CITY OF ALBUQUERQUE

July 24, 2017

**Re: GAHP Casa Feliz
421 Espanola Street SE
Request for Permanent C. O. – Not Accepted
Engineers Stamp Date 12/18/15 (L19D073F)
Certification dated: 7/18/2017**

CD-208

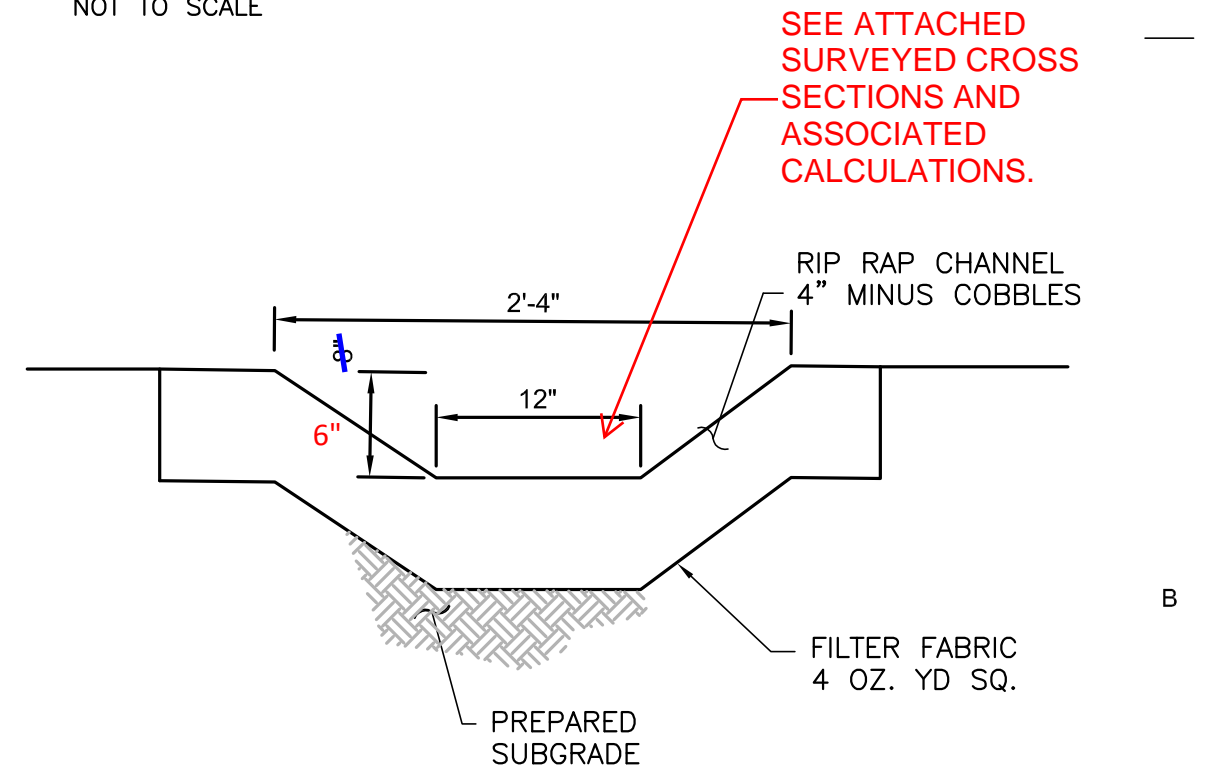
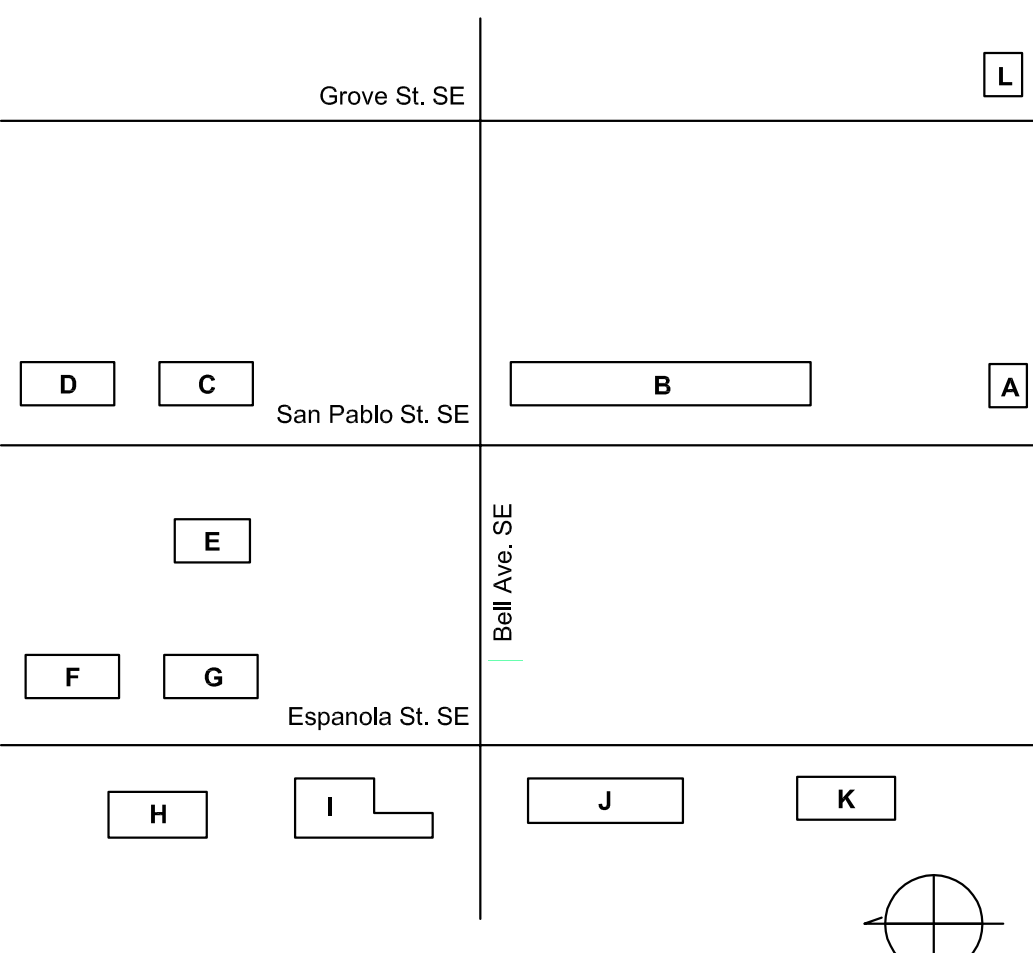
1. Even though your certification and associated survey claims a 6" deep channel on the south side of the site, at our site meeting on 7/20/2017 it appeared that most of that depth is loose landscape rock that won't hold water. So the Grading Plan must be revised and resubmitted to hydrology to include a design of a wall or curb along the south property line as necessary to prevent cross lot drainage. The revised plan should include a new engineer's stamp date.
2. The revised plan should also include a cross-section through the swale and property line and show this sit 1' higher than the adjacent site as shown at section D on the surveyed sections. Manning's "n" value in the channel calculations also needs correction from 0.025 to 0.045 for rip-rap.

INFRASTRUCTURE AS-BUILT

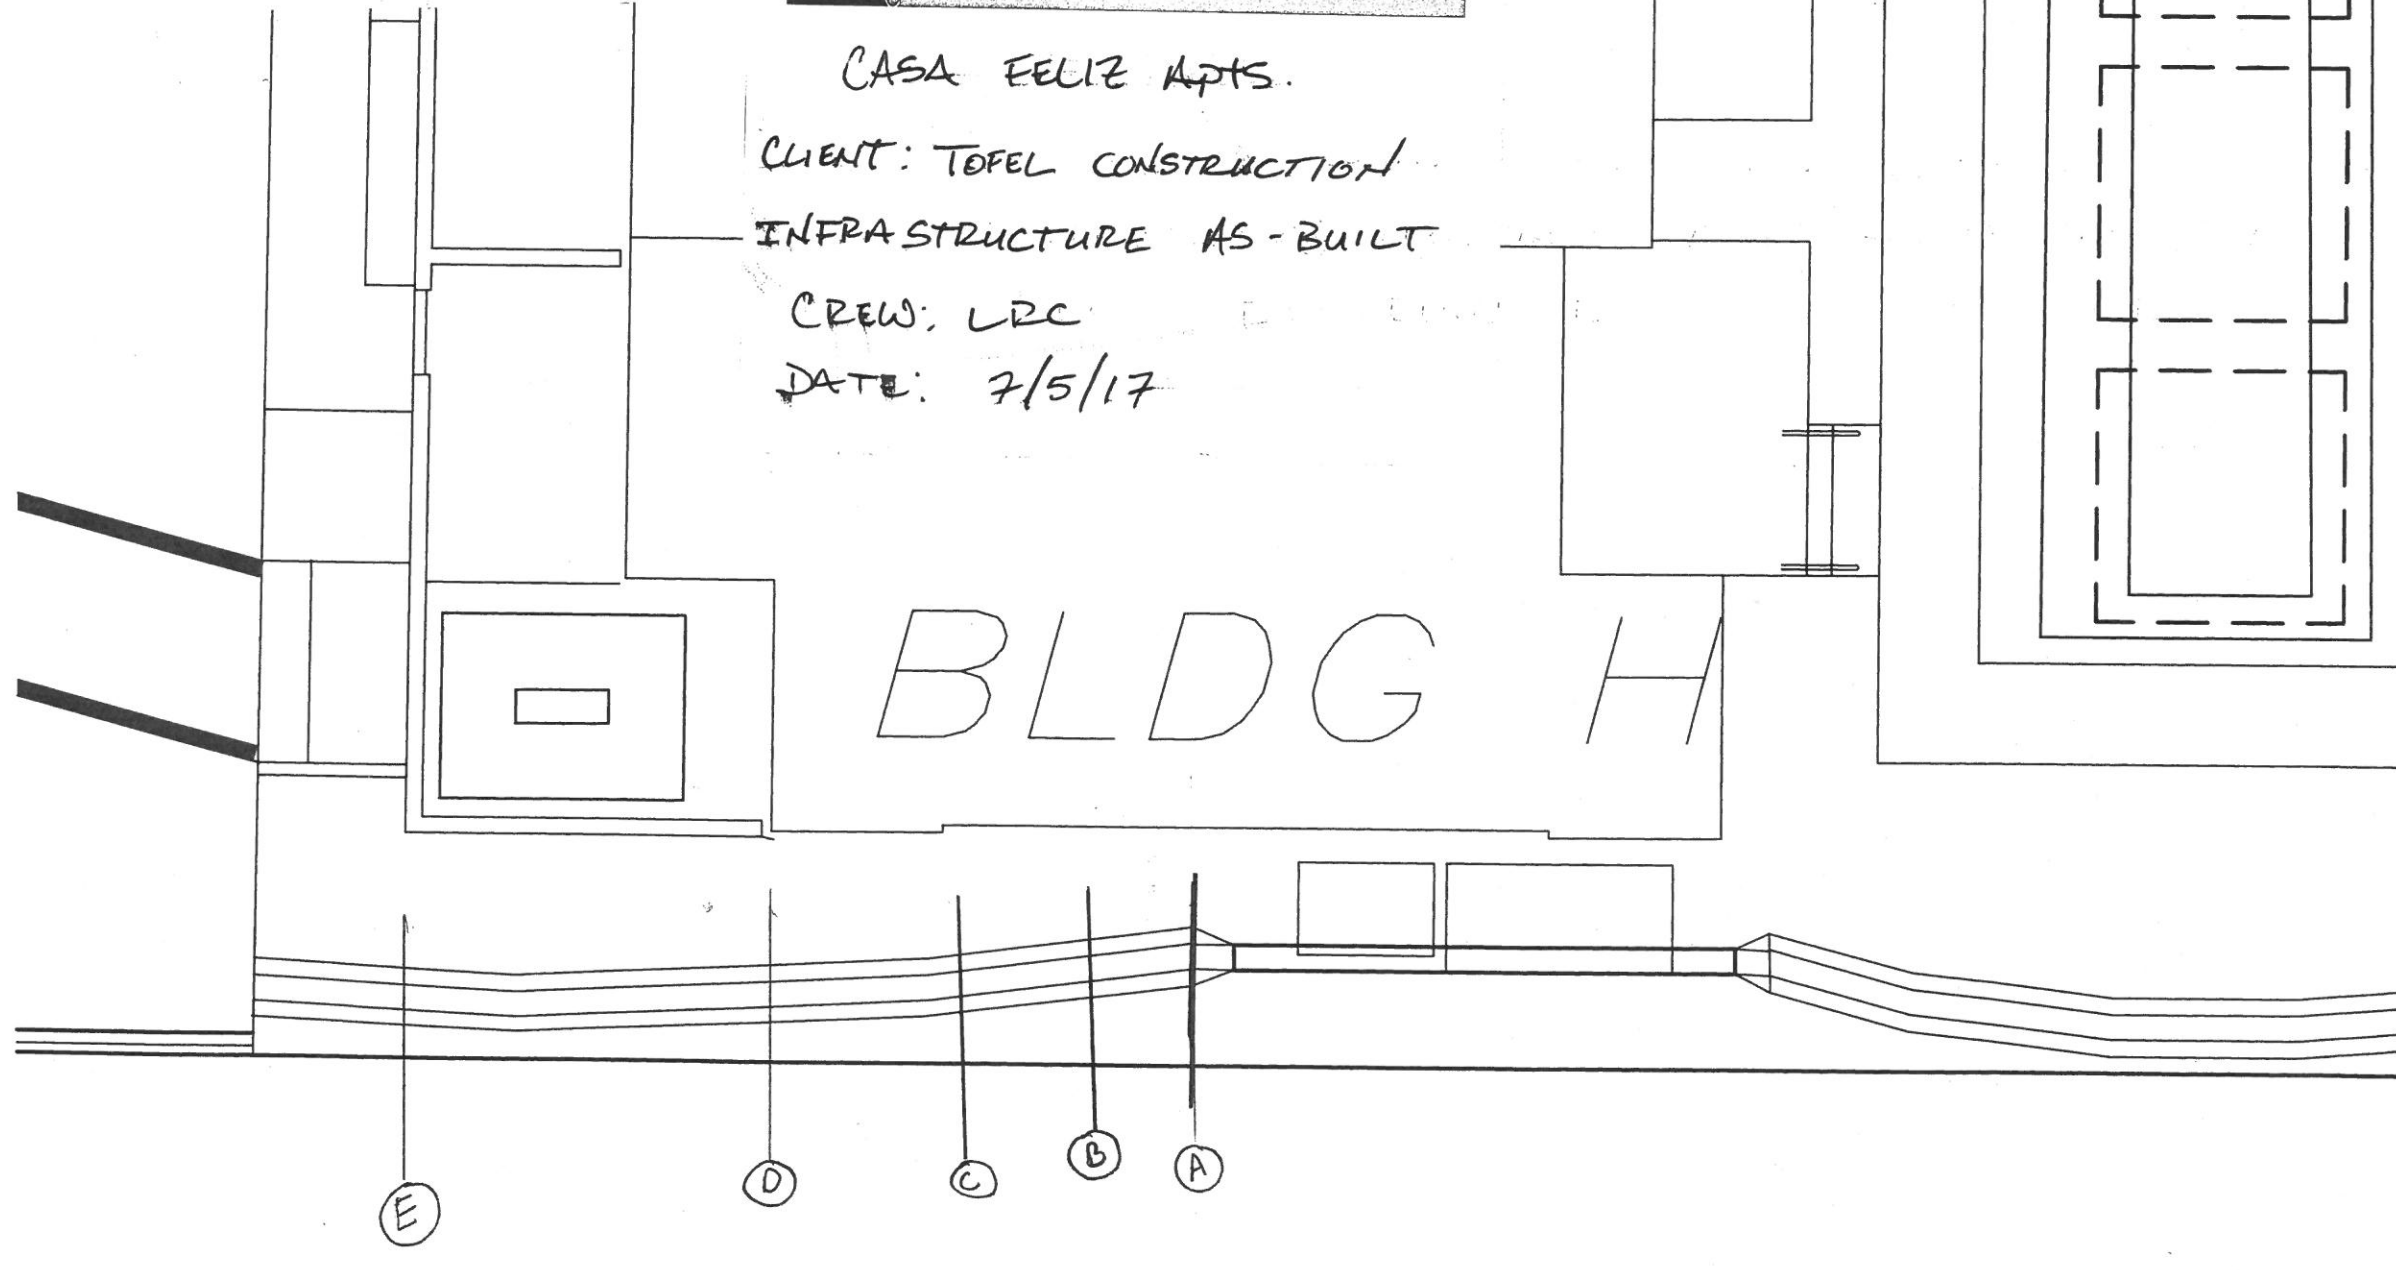
2. As-built survey information should be added to the plan to include spot elevations throughout the parking lot, the swale , and the finished floor elevations as well as the top of the new wall to be added on the south side of the property.
